UNITED STATES
NUCLEAR REGULATORY COMMISSION
WASHINGTON, D. C. 20555

Docket Nos.: STN 50-454
and STN 50-455

APPLICANT: COMMONWEALTH EDISON COMPANY
FACILITIES: BYRON STATION, UNITS 1 AND 2
SUBJECT: MEETING SUMMARY - REVIEW OF BYRON LCO RELAXATION PROGRAM

Model 1

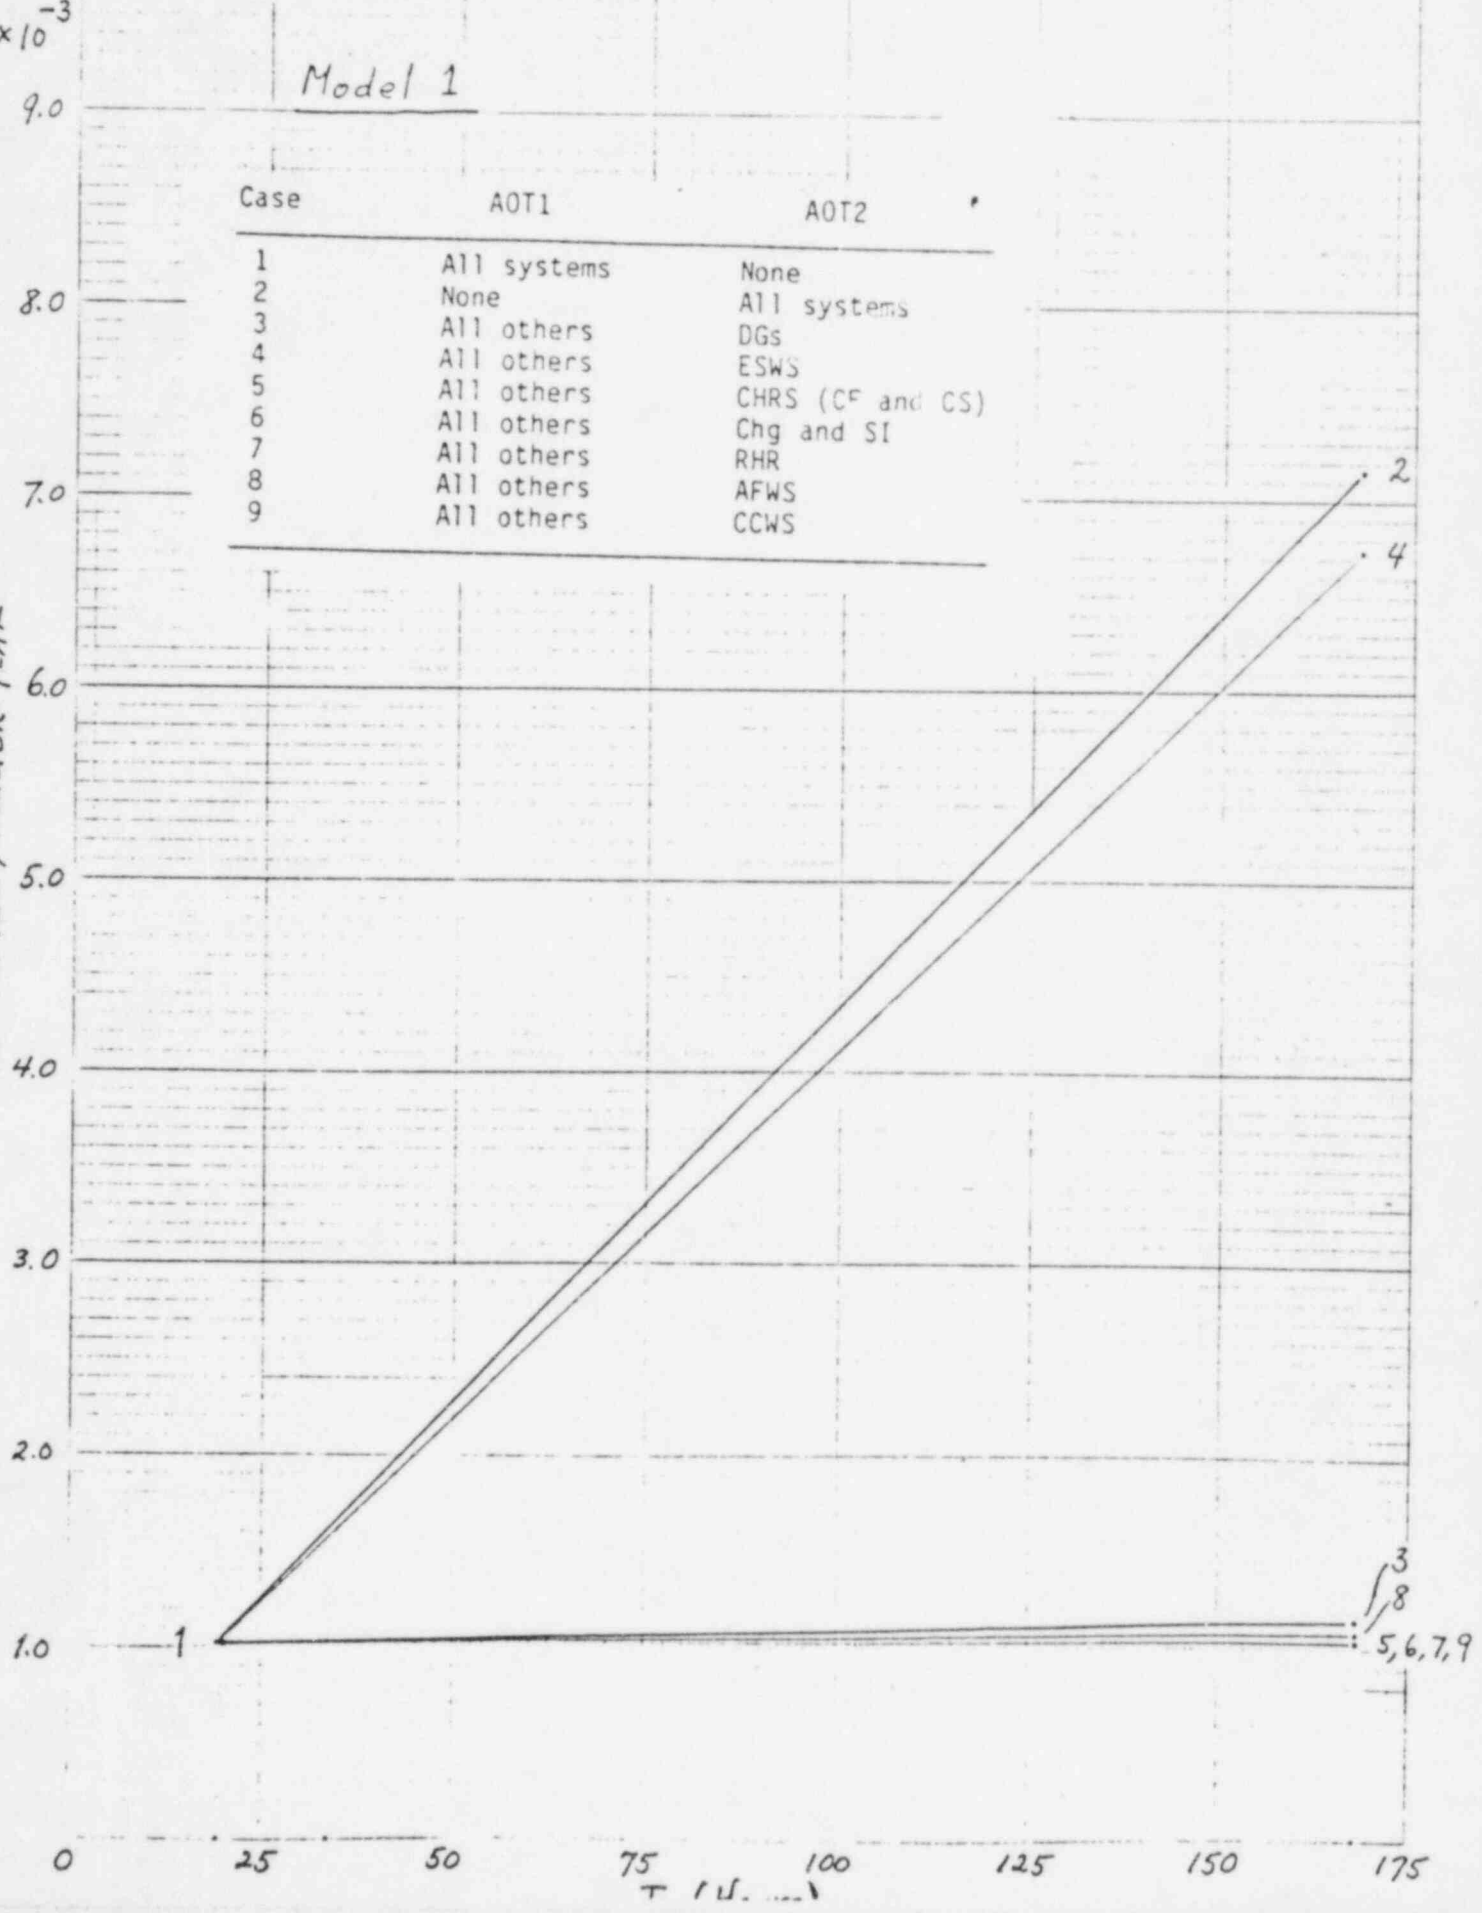
COMPARISON OF MEAN CORE DAMAGE FREQUENCIES
FROM ONE UNIT OPERATION

Model 3

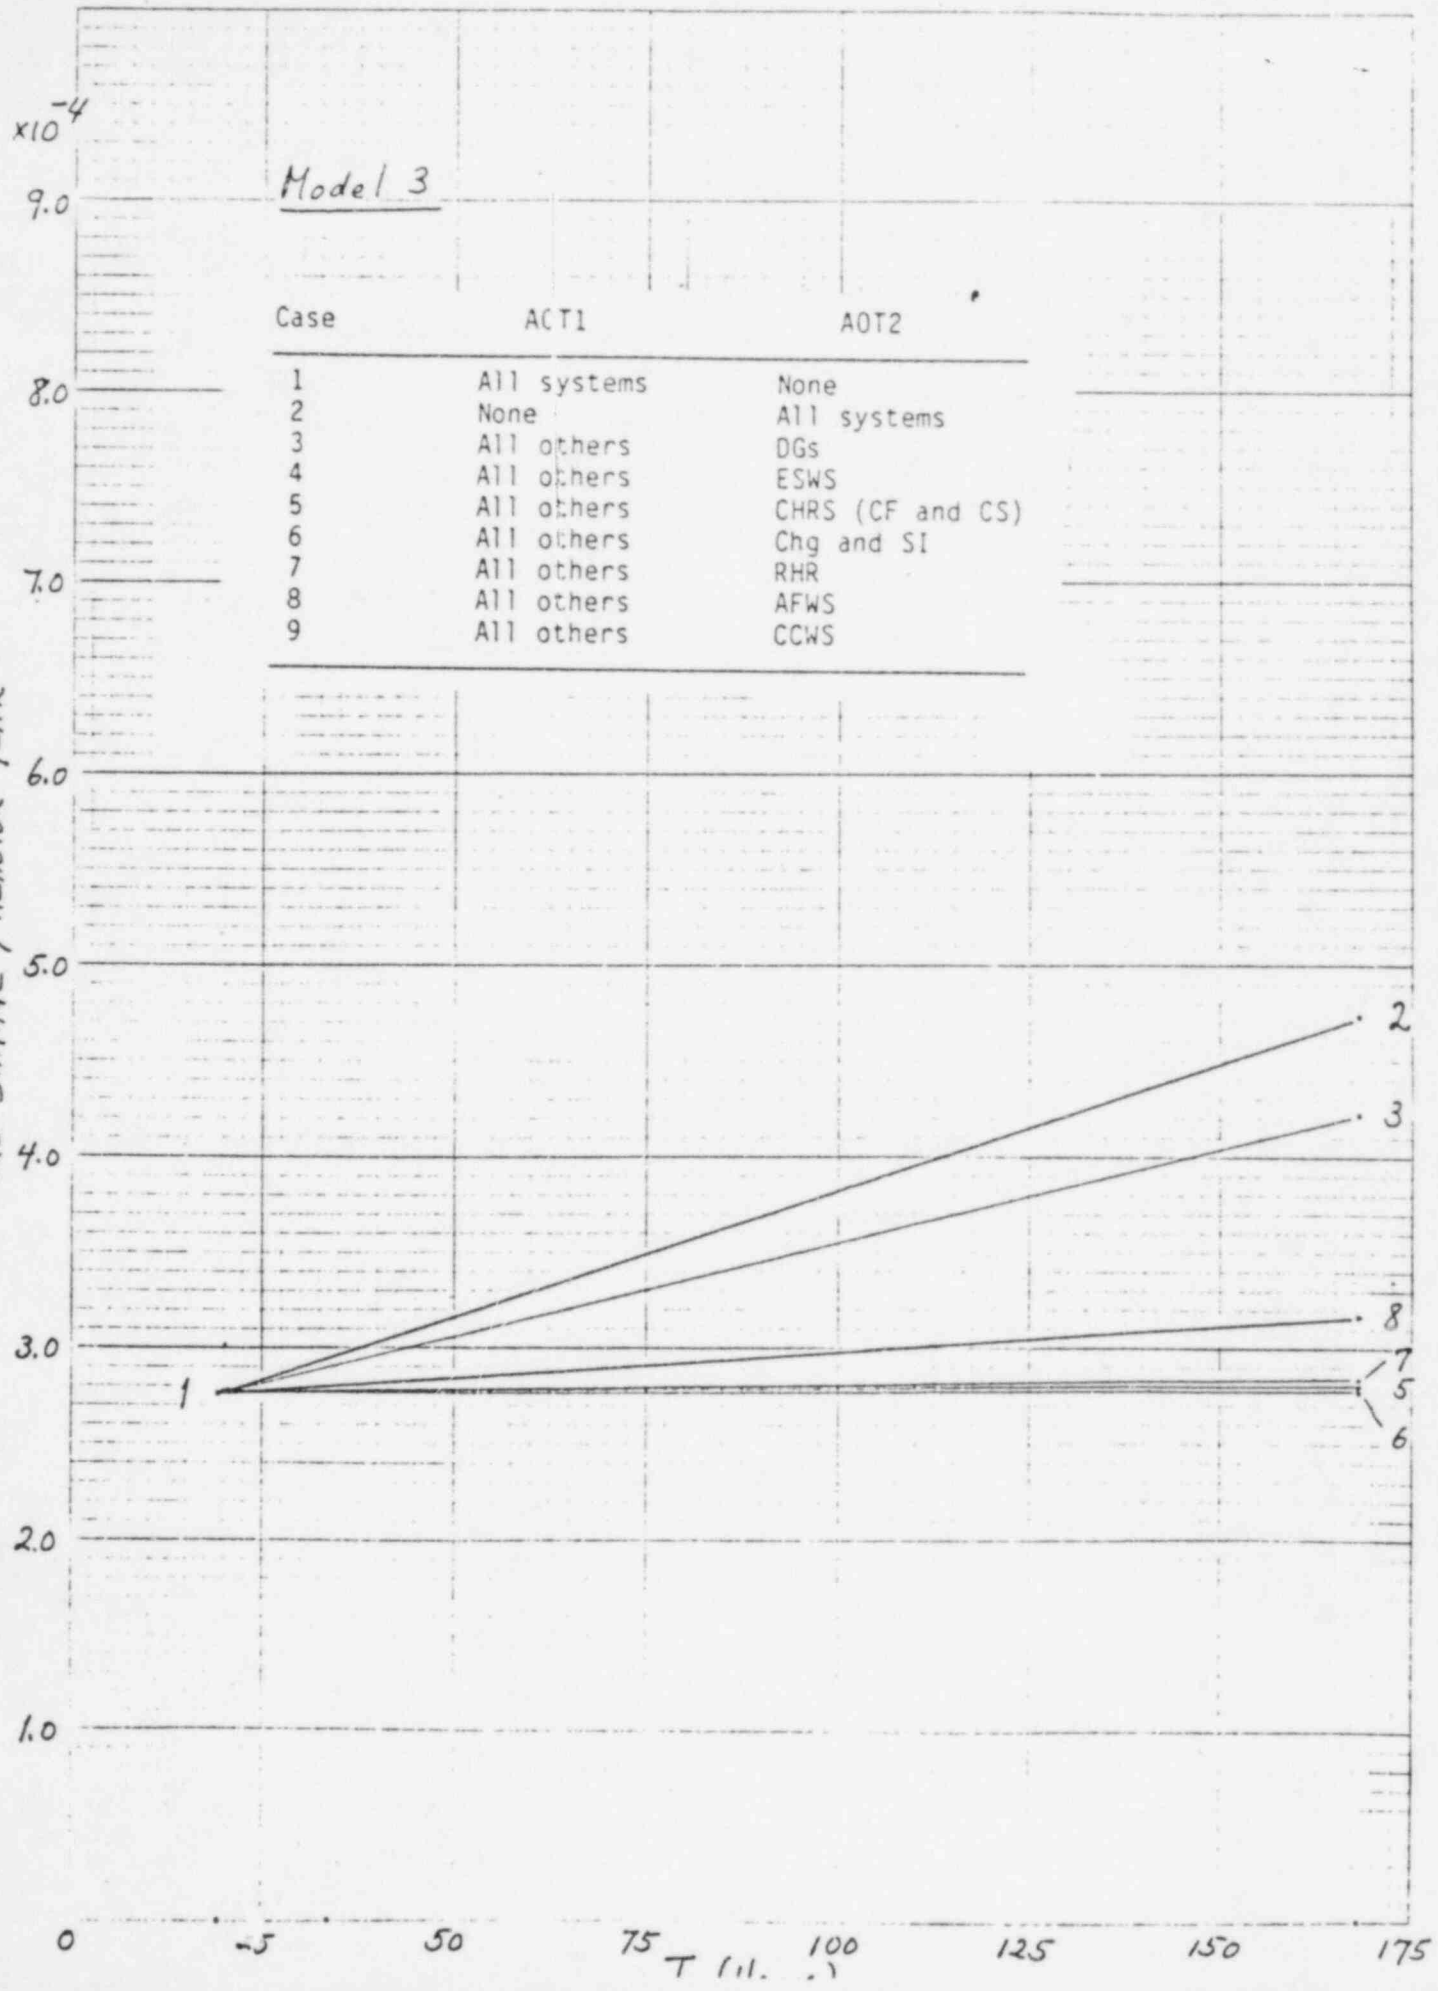
CORE DAMAGE / REACTOR YEAR
